METROPOLITAN GOVERNMENT OF NASHVILLE AND DAVIDSON COUNTY

STAFF RECOMMENDATION
2815 27th Avenue South
August 20, 2014

Application: New construction-infill and outbuilding
District: Hillsboro-West End Neighborhood Conservation Zoning Overlay
Council District: 18
Map and Parcel Number: 11703015400
Applicant: Brad Skipper
Project Lead: Sean Alexander, sean.alexander@nashville.gov

The vacant lot that is 2815 27th Avenue South.

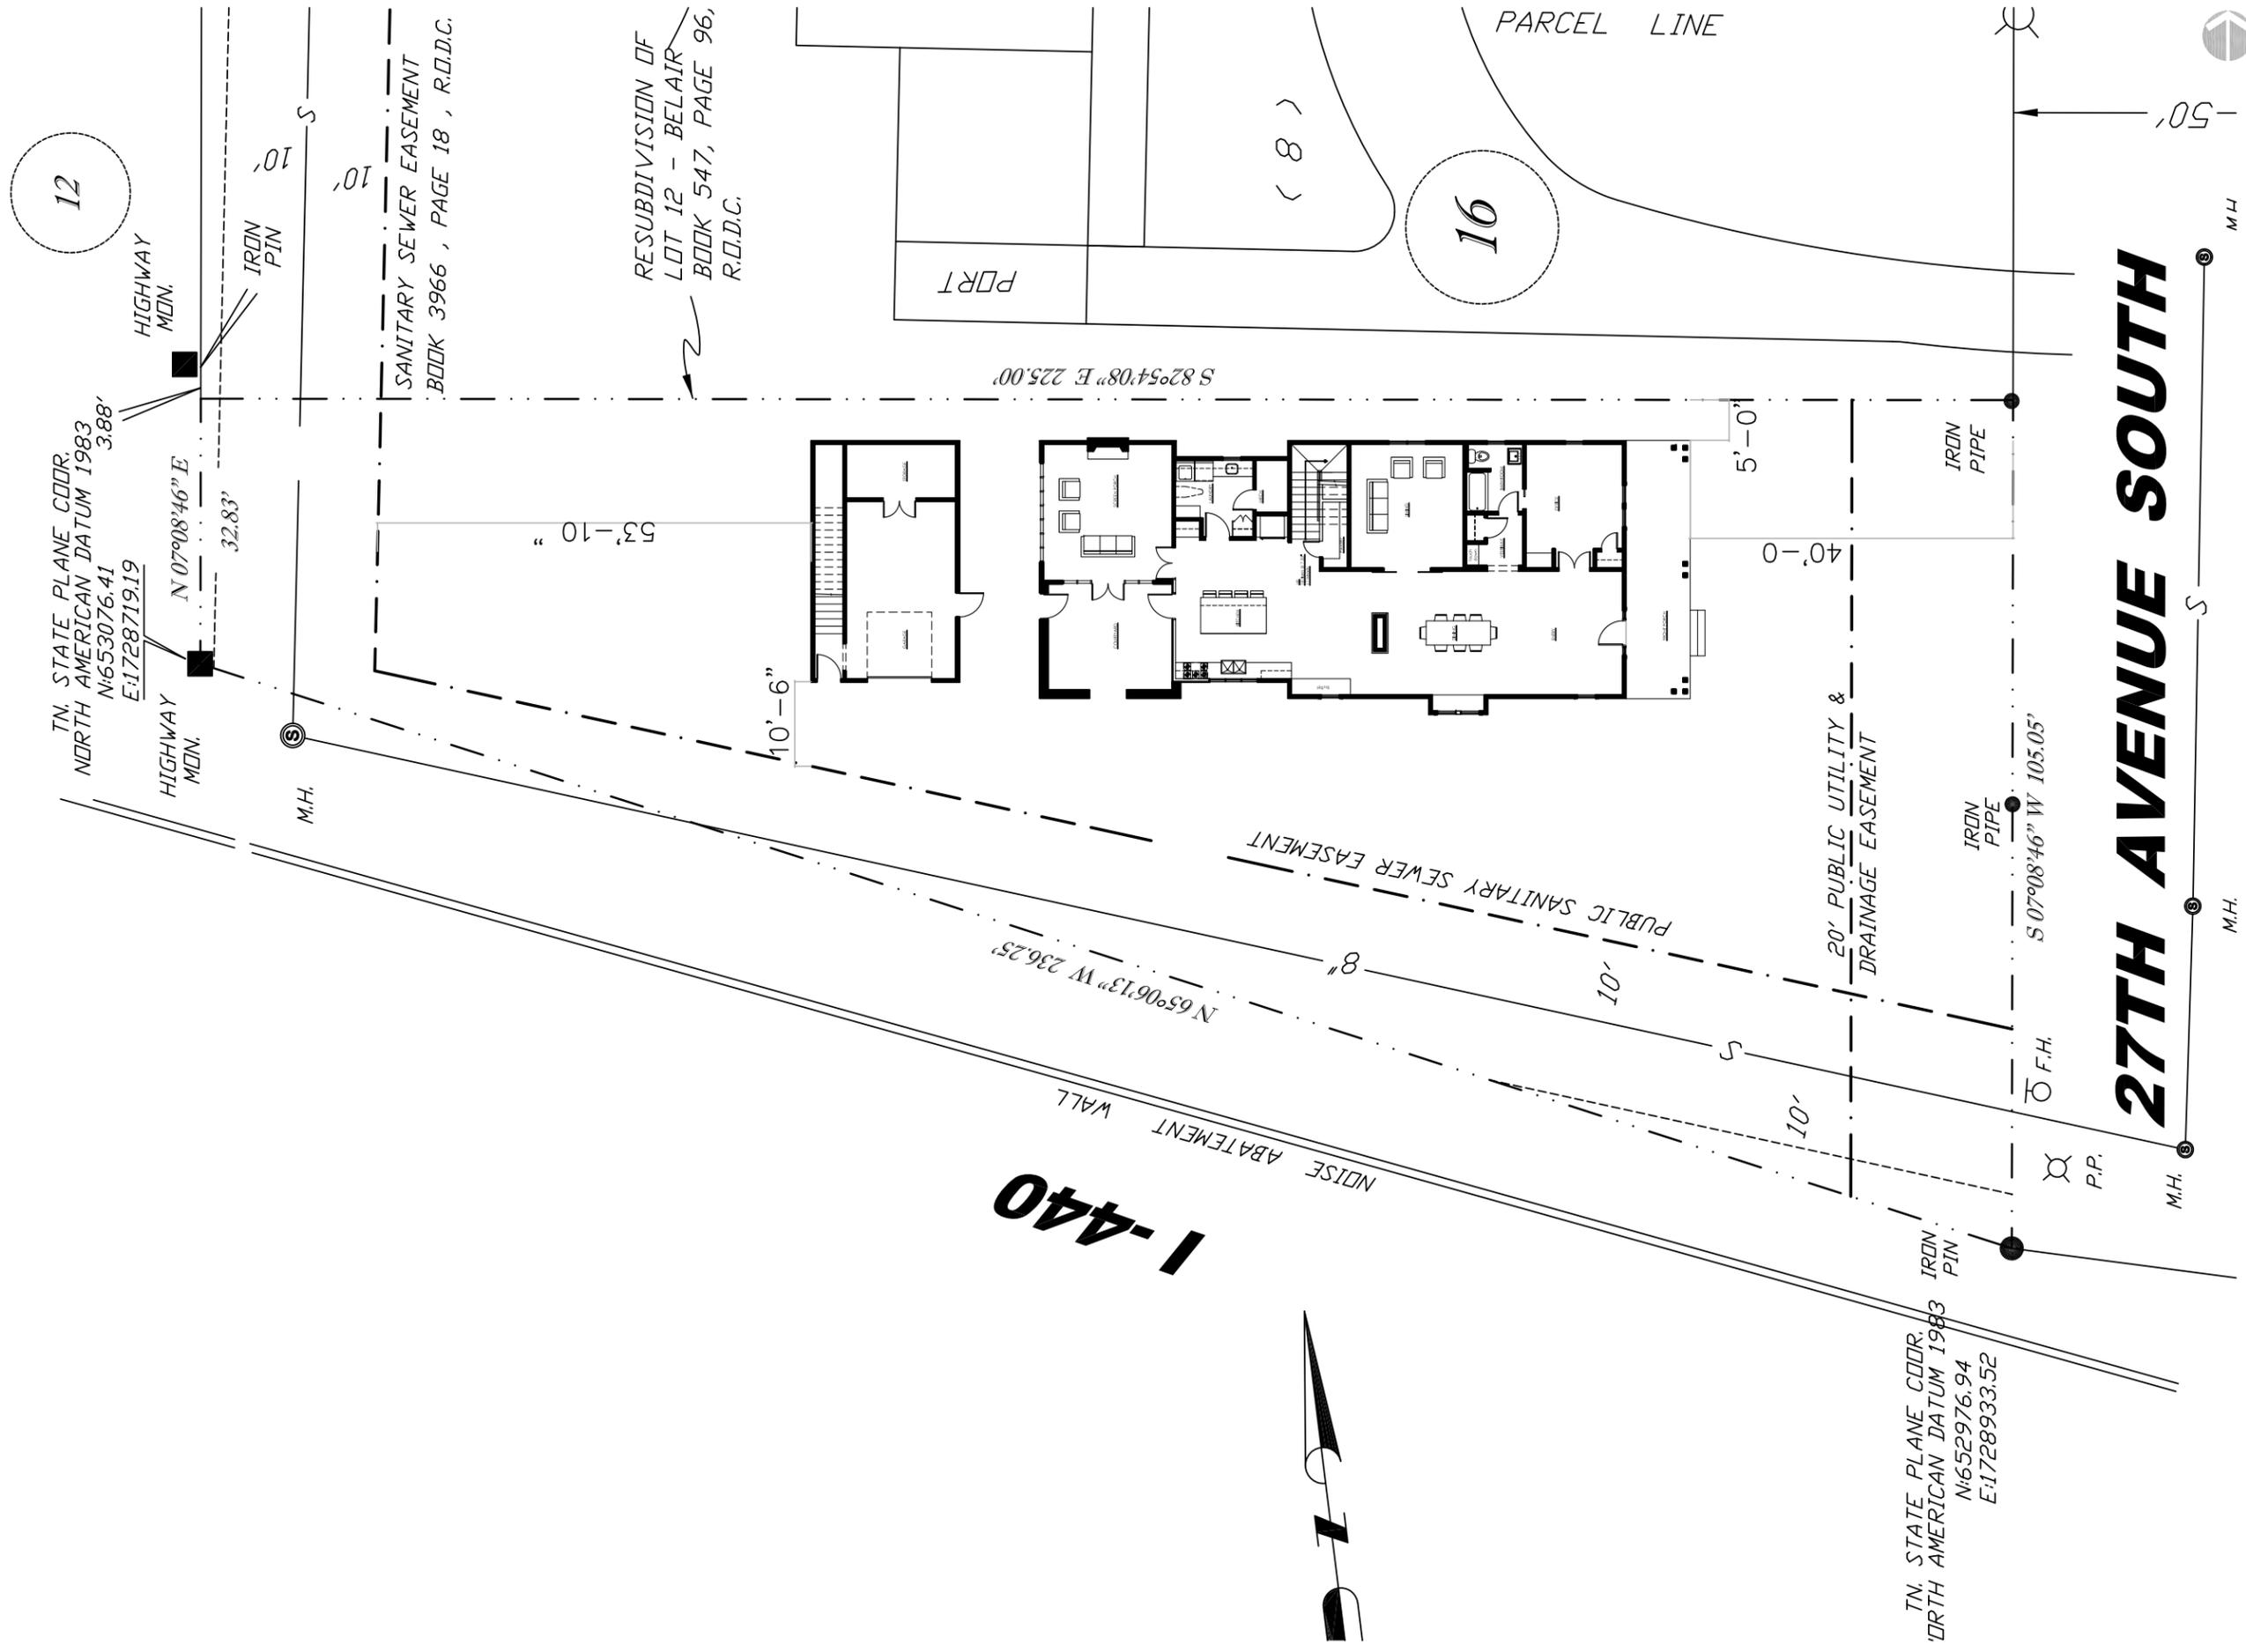
Background: 2815 27th Avenue South is a vacant triangular shaped lot between the I-440 highway and a historic building.
